Errata for the
PCI Express[®] Base Specification
Revision 2.1

June 8, 2010

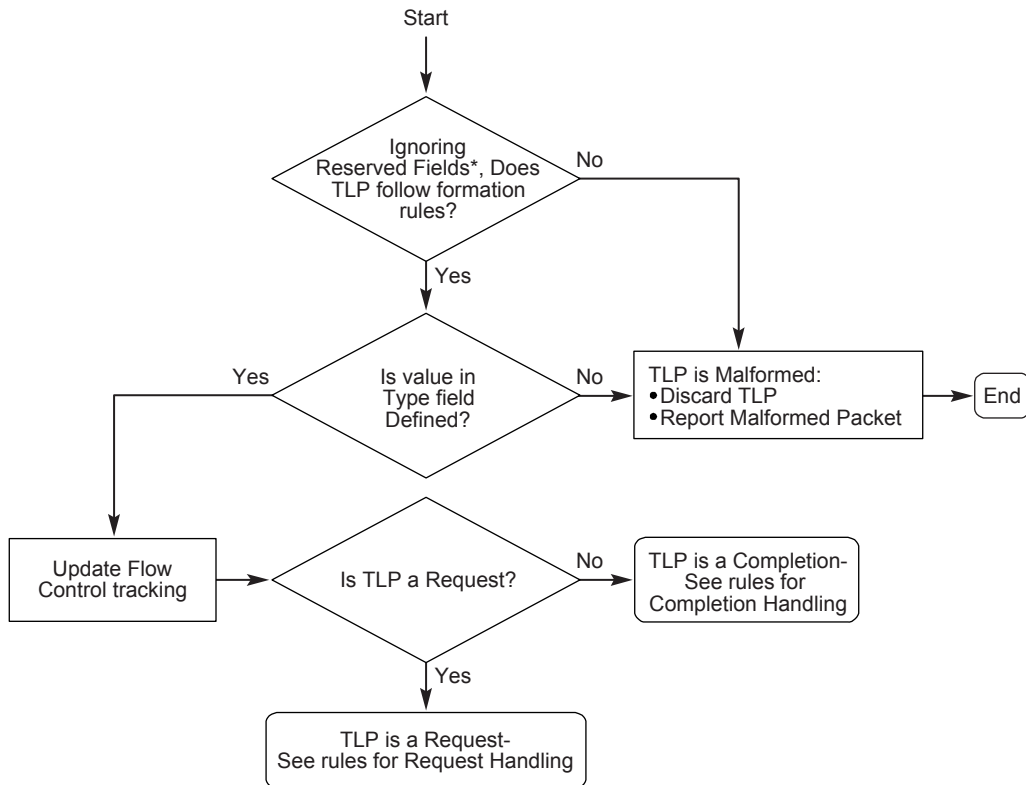
In Section 2.3, page 102, replace Figure 2-30: Flowchart for Handling of Received TLPs with the following:

*TLP fields which are marked Reserved are not checked at the Receiver

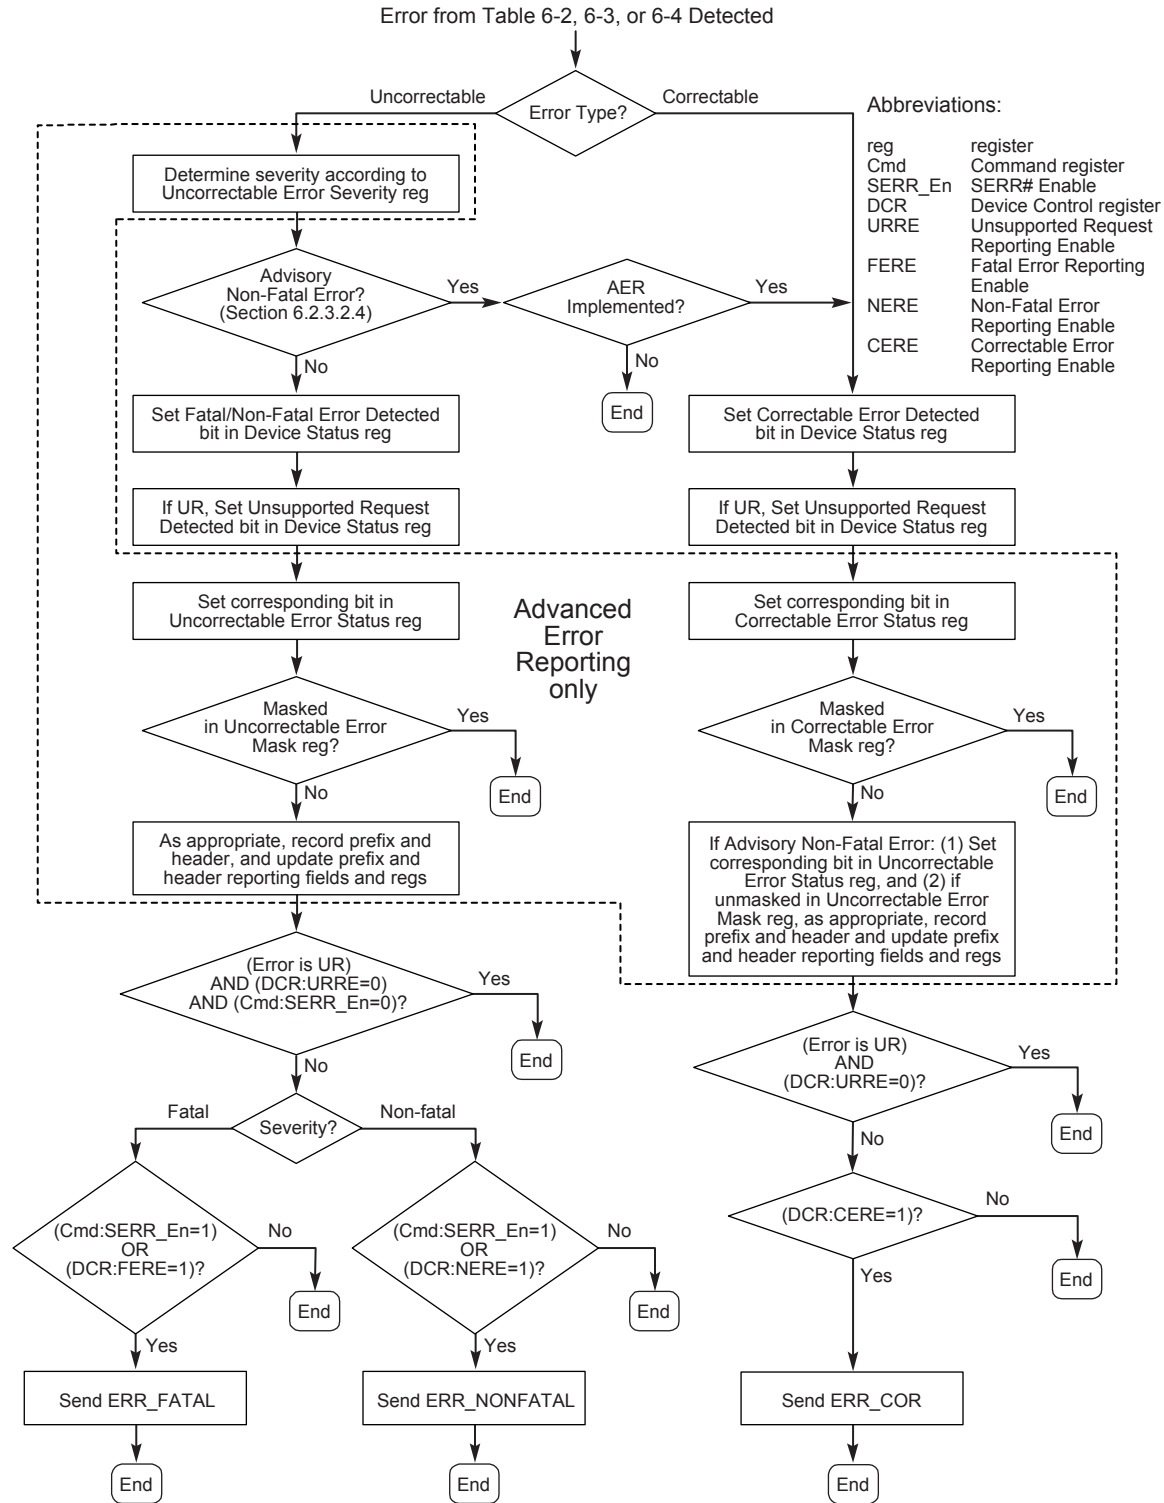
In Section 6.2.5, page 377, replace Figure 6-2: Flowchart Showing Sequence of Device Error Signaling and Logging Operations with the following:

OM14544C

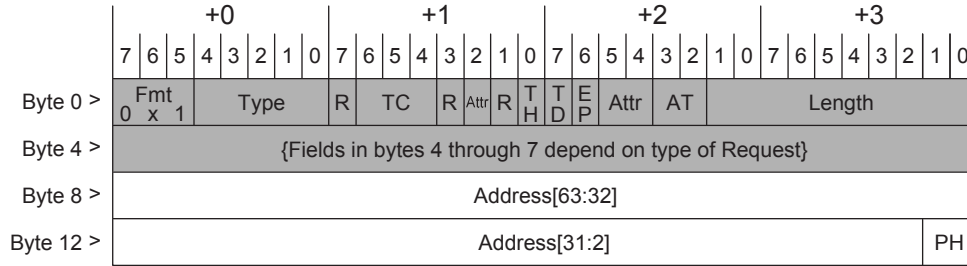
In Section 2.2.4.1, page 64, replace Figure 2-7: 64-bit Address Routing with the following:

OM14543C

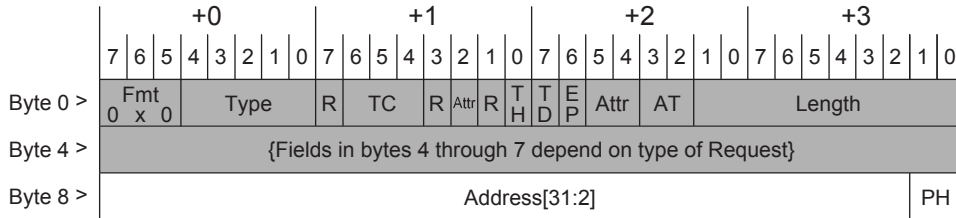
In Section 2.2.4.1, page 64, replace Figure 2-8: 32-bit Address Routing with the following:

OM13764C

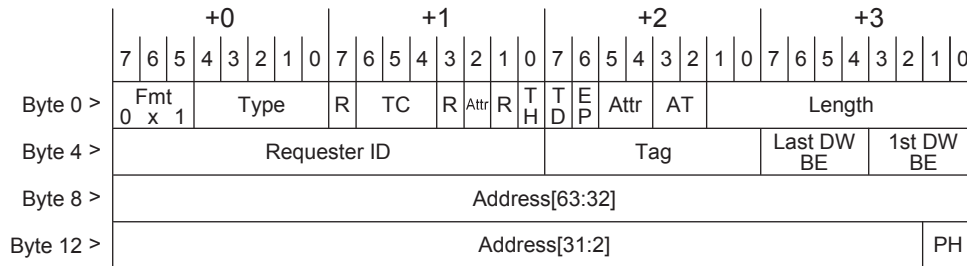
In Section 2.2.7, page 77, replace Figure 2-15: Request Header Format for 64-bit Addressing of Memory with the following:

OM13763C

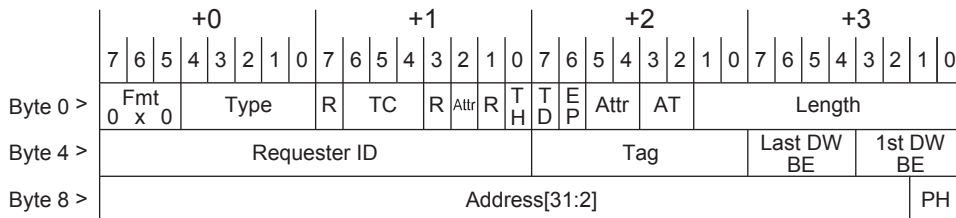
In Section 2.2.7, page 77, replace Figure 2-16: Request Header Format for 32-bit Addressing of Memory with the following:

A-0779A

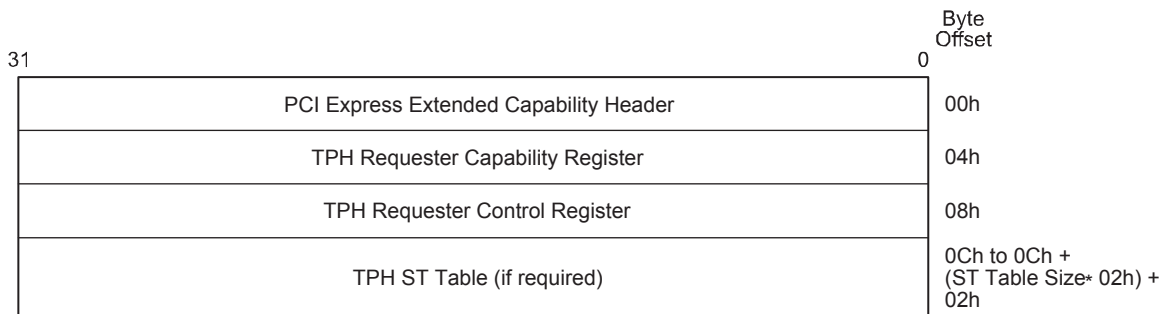
In Section 7.26, page 653, replace Figure 7-126: TPH Extended Capability Structure with the following:
